SAFETY EVALUATION BY THE OFFICE OF NEW REACTORS
LICENSING TOPICAL REPORT MUAP-07006-P (REVISION 2)

"DEFENSE-IN-DEPTH AND DIVERSITY"

MITSUBISHI HEAVY INDUSTRIES, LTD.

Figure 2. RPS and ESFAS interface [Source: MUAP-07004-P, Rev. 2]

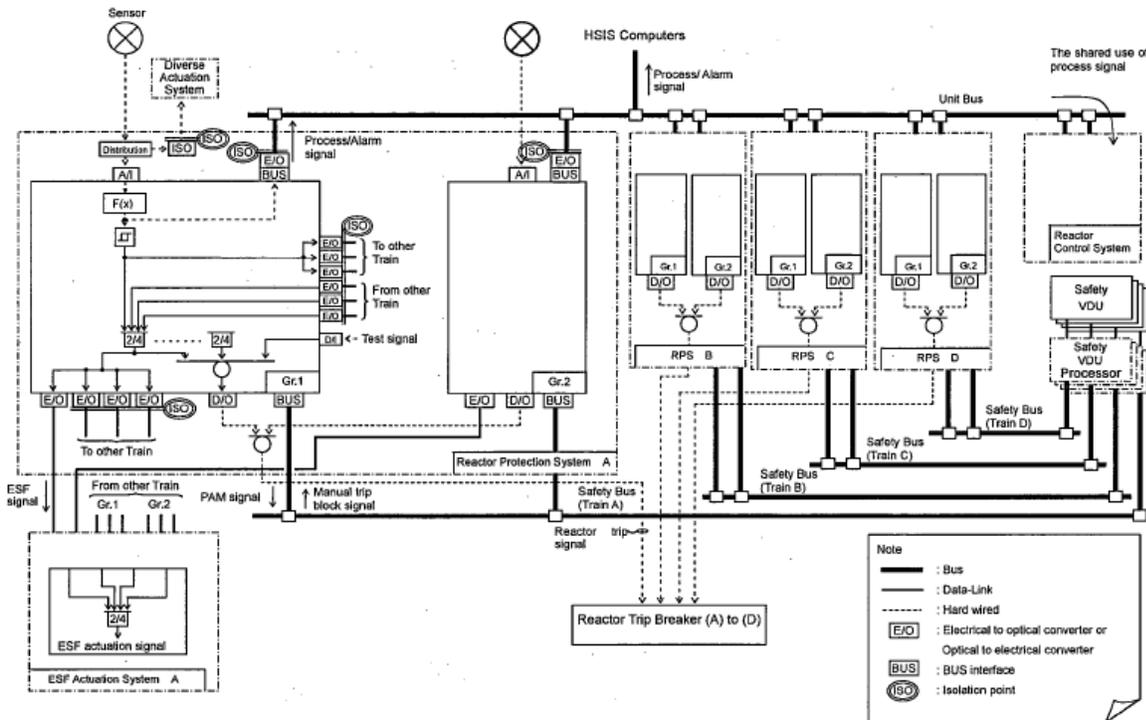
Figure 2 illustrates how two diverse sensor values are provided to the processors in each of the four PSMS divisions (one sensor value to the processor in Group 1, the other sensor signal to the processor in Group 2 within the same division). Analog sensor values are transmitted through an isolator to the DAS; the same analog sensor signals are then digitized and transmitted to the PSMS.

Sensor signals common to reactor trip and/or engineered safety feature actuation system (ESFAS) are transmitted to the reactor protection system (RPS) of the PSMS. The sensor signals are processed through setpoint comparison function blocks (bistables). There are separate bistables for each reactor trip and engineered safety feature (ESF) when there are differences in setpoint values. Bistable outputs from each train of the PSMS are combined using a 2-out-of-4 voting logic scheme. The voting logic outputs for a reactor trip are interfaced to the reactor trip breakers. The voting logic outputs for ESF actuation are transmitted to the ESFAS section of the PSMS.

Each ESFAS train processes the signals from all four respective trains in the PSMS divisions with 2-out-of-4 voting logic for the ESF actuation. Further description of the PSMS architecture is provided in Topical Report MUAP-07004-P, "Safety I&C System Description and Design Process," Revision 1.
